## INDEPENDENT MONITOR'S AUDIT OF THE MCARTHUR RIVER MINE FOR THE 2010 OPERATIONAL PERIOD

**ENVIRONMENTAL EARTH SCIENCES VIC**  
REPORT TO THE MINISTER FOR PRIMARY INDUSTRY FISHERIES AND  
RESOURCES  
OCTOBER 2011  
VERSION 1

## 9.3 Review of dust monitoring

**Plate 10** PACRIM area. Note fugitive dust in the centre of the photo. We note that MRM have advised that limiting dust emissions completely from this plant may not be possible. Photo: Independent Monitor 2011.

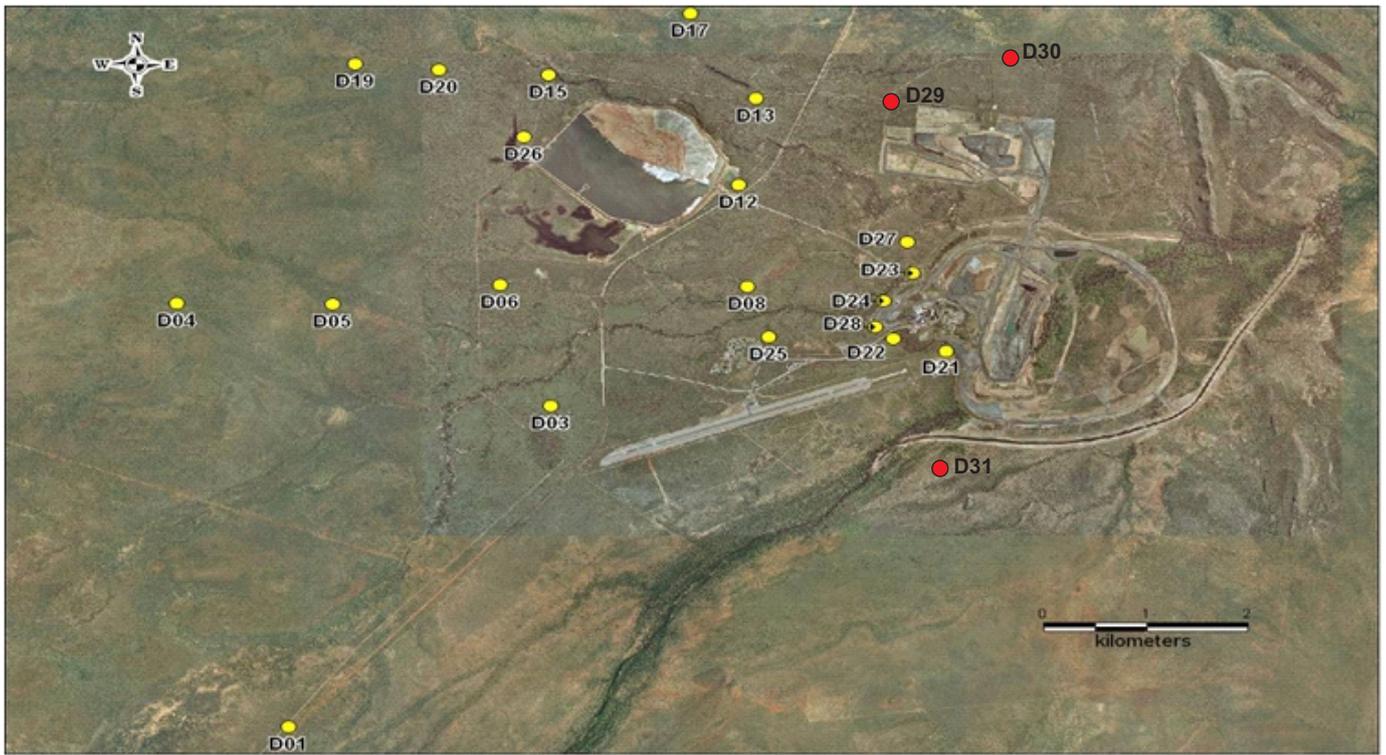
Dust remains as an issue in this audit. At the mine site the main source of contaminated dust is from the operation of the PACRIM crusher plant. During its May 2011 site inspection, the IM observed dust emanating from the PACRIM plant (Plate 10), and noted dust settled on surrounding objects (Plate 7). No significant improvements to dust management from the PACRIM were observed this audit. However, we do note that MRM have advised that limiting dust emissions completely from this plant may not be possible.

However, MRM staff did advise that an additional hood had been placed on the plant to try to limit dust, and that sprays were working throughout the plant to suppress dust. The IM also observed that a spray at the top end of the PACRIM conveyor line is now used constantly rather than intermittently (Plate 8).

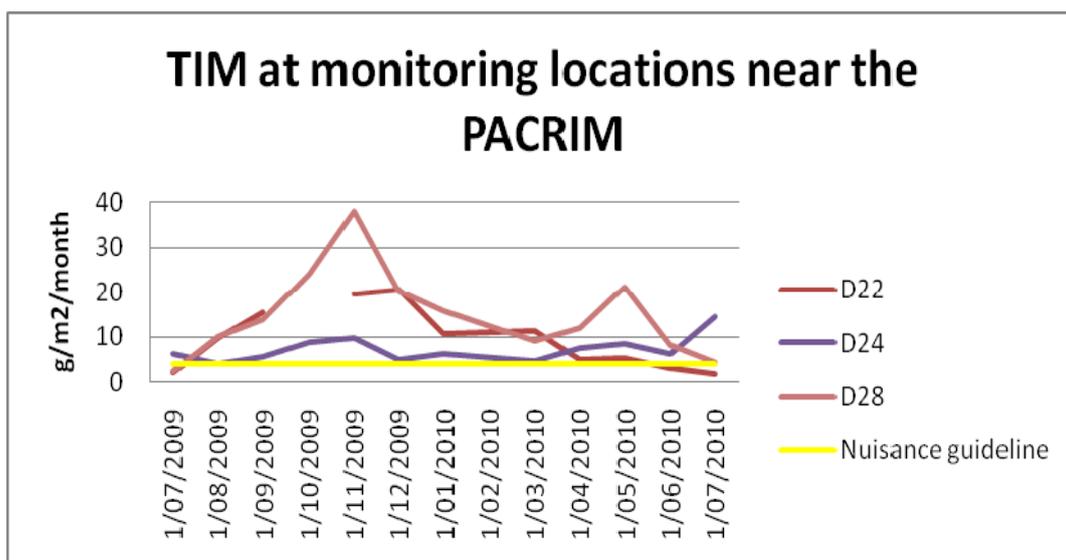
- the MMP does not contain discussion of results or concentration charts for several locations including: PACRIM: D27, D22 and D21; and mine site locations: D04, D17, D06, D03, D20, D08, D25 and D05. It is unclear why these results are not reported. If

results are not reported because they are deemed to be low or not likely to pose an environmental hazard, then this should be clarified in the MMP for completeness.

**Plate 9** Aerial photograph showing the position of the Bing Bong concentrate storage shed in relation to the prevailing North West wind direction. Photo: Independent Monitor 2011.

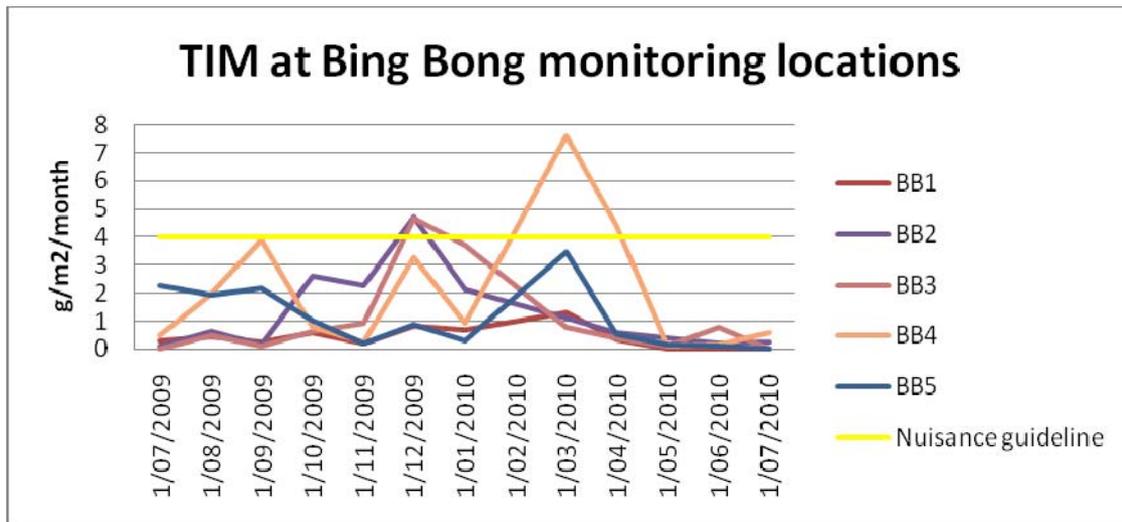
At the Bing Bong Port Facility contaminated dust issues are primarily associated with the concentrate storage shed. Because the shed doors must be kept open to prevent gas build-up, the prevailing winds can pick up dust from within the shed and transport it to the surrounding landscape and marine waters/sediments (Plate 9). Further, the condition of the corrugated iron shed walls was observed to be still poor in many places, with many small holes allowing the potential escape of concentrate dust. These issues have been identified by the Independent Monitor in past years.

- although monitoring location BB1 at Bing Bong Port recorded dust lead concentrations of up to  $600\,000 \text{ mg/kg}$  (or 60%), the TIM at this location has decreased since the last monitoring period; this finding highlights the fact that, although total dust collected at this site may have decreased, the dust that was collected is contaminated with a high proportion of lead, which is likely to have originated from concentrate stored at Bing Bong Port (see Plate 9).

During the inspection, MRM advised that capital expenditures to upgrade the shed have now been approved. These upgrades will include a shed ventilation system which will allow the shed doors to be kept shut. The IM looks forward to seeing these improvements next audit.

**Chart 3** TIM at Bing Bong monitoring locations D12, D21 and D6.

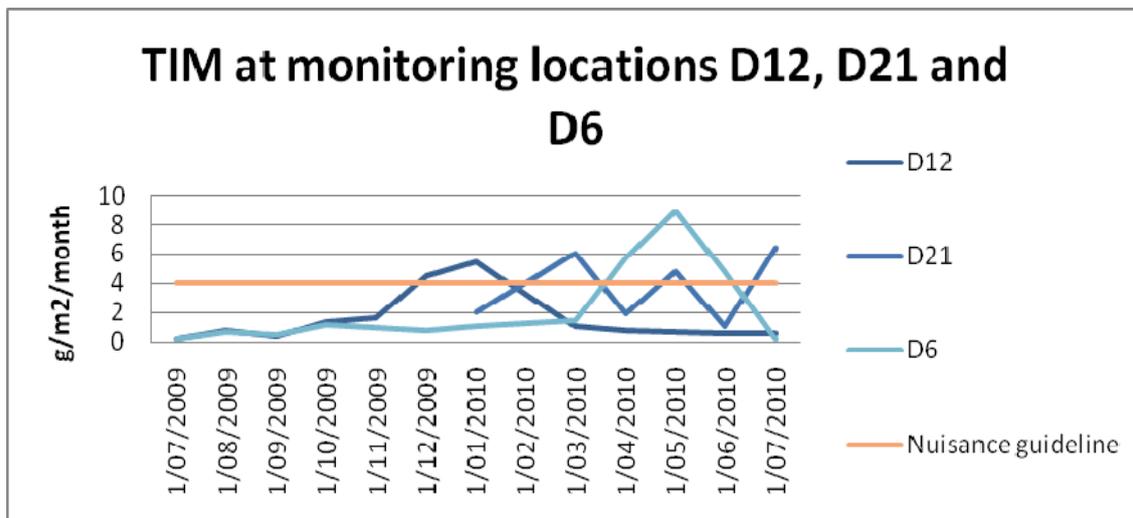
As can be seen in Charts 1 to 3, high dust levels (TIM) have been recorded at monitoring locations near the PACRIM: D22, D24 and D28 (see Figure 5 for locations). Elevated lead concentrations have also been recorded at these locations and it is therefore recommended that further mitigation measures should be implemented. In addition, elevated TIM levels may be an issue at monitoring location Bing Bong Port BB3, being the highest concentration over the nuisance level, and mine site D12, D21 and D6, being the highest concentrations at the mine site.
